**ENVIRONMENT & WATER RESOURCES MANAGEMENT**

Ms. Linda Lehman has requested that EWA, Inc. supply you with a copy of an EWA technical document titled "Critical Assessment of the Tectonic Stability of the Reference Repository Location" in regard to the BWIP project. Should you have any comments or questions regarding this document, please feel free to contact me at (612) 559-3706.

**TO:** Hanford File, Task II.2.B.iv  
**FROM:** K. Shimko, V.V. Nguyen, J. Ryan /EWA, Inc.  
**SUBJECT:** Critical Assessment of the Tectonic Stability of the Reference Repository Location  
**DATE:** March 31, 1985

Figure 1 - Diagram showing how paleoslope is used to estimate subsidence and/or uplift.

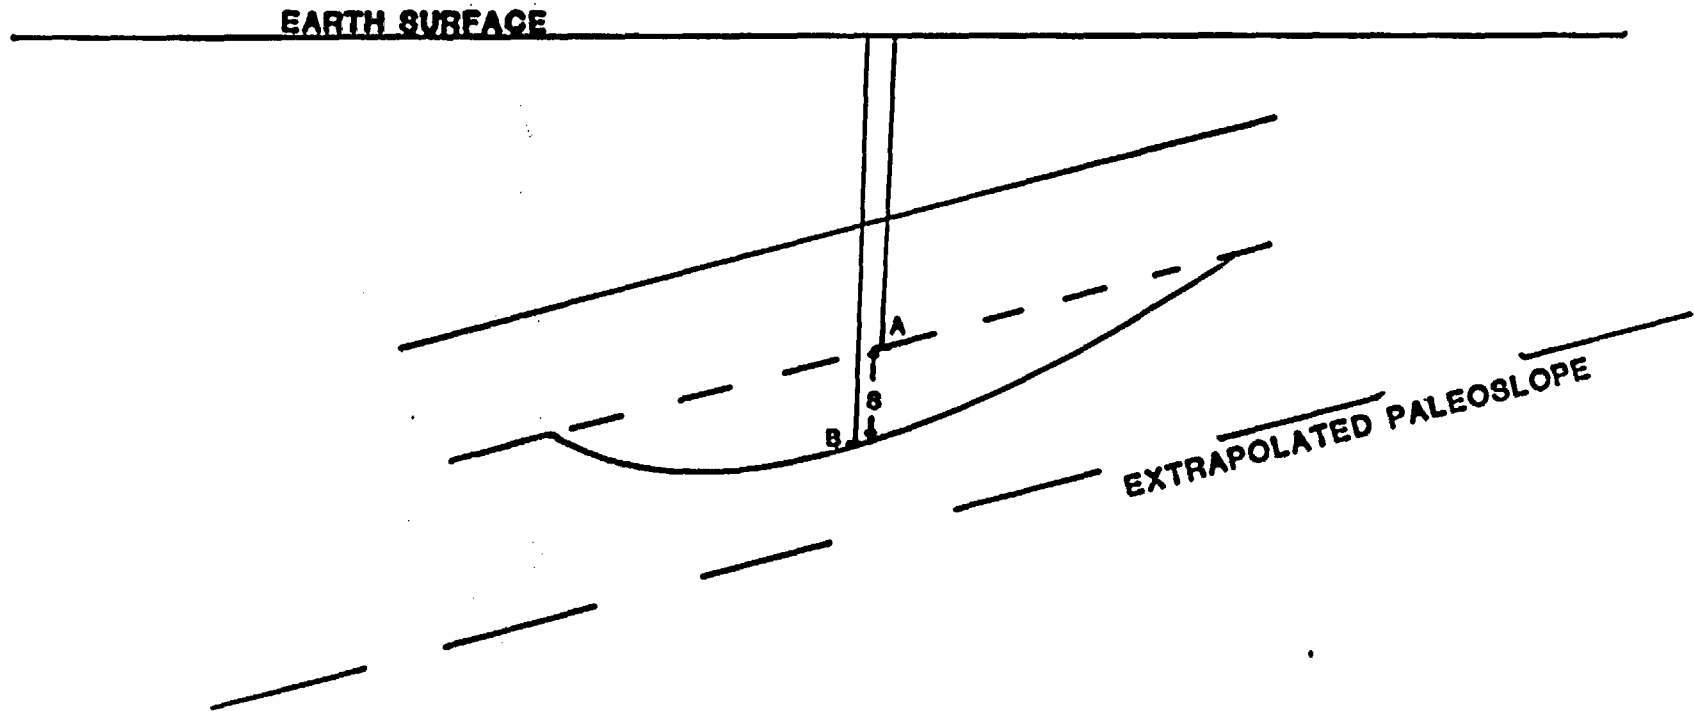
The "true thickness" is determined by an extrapolation of the paleoslope to the borehole. This method does not take into account structural control of the extrapolated paleoslope's elevation at the measuring point. Also, the location of measurement directly affects the subsidence or uplift values because the thickness of the basalt flows varies laterally along a slope.

The regional paleoslope is not necessarily a reliable reference point. Subsidence or uplift of the paleoslope has been associated with the emplacement of the Idaho batholith which introduces error into the measurements made by Reidel, et.al. (1983). That is, if the paleoslope is uplifting, subsidence values for the Pasco Basin area will be too large and calculated uplift will be too small.
